DOD Compressor 280A

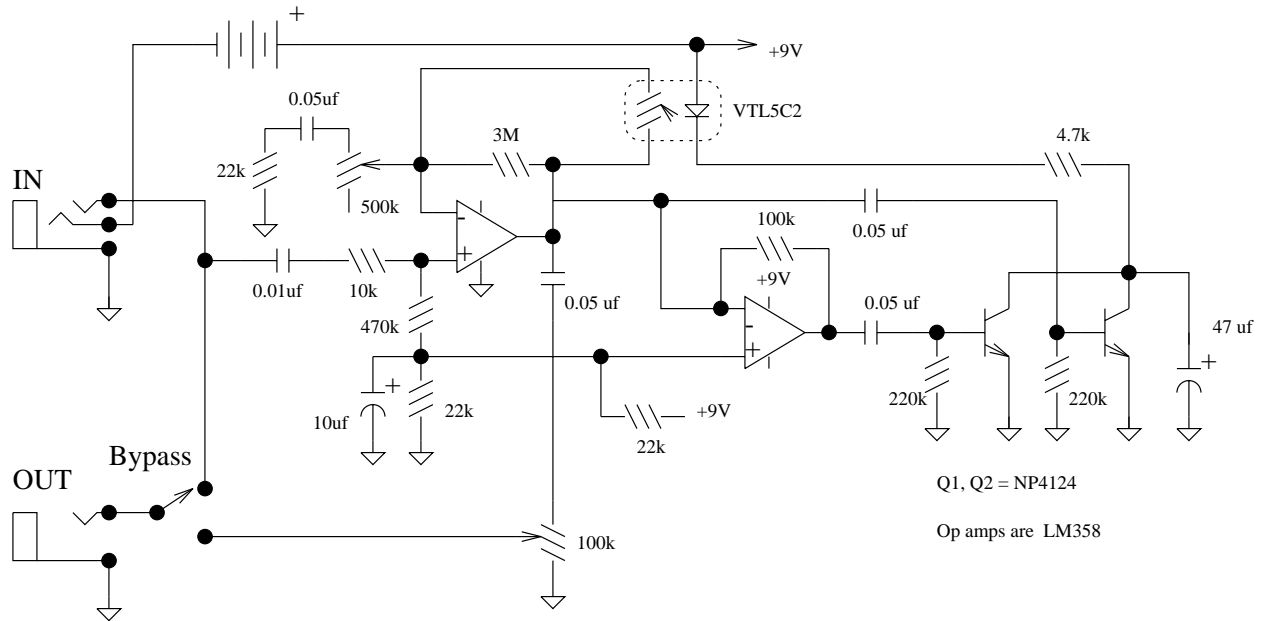
This is the original schematic, but it looks funny to me. I think that there should be a 100k resistor at the (-) input of the second opamp to make it a pure inverter. As it is, that stage would have a very large voltage gain, unbalancing what I think works as a full wave rectifier/current source for the LED in the compression feedback loop. I would expect that the proper circuit is as shown in the fragment below. I think the VTL5C2 LED/LDR module could be replaced with a CLM6000 if you could find one of those.
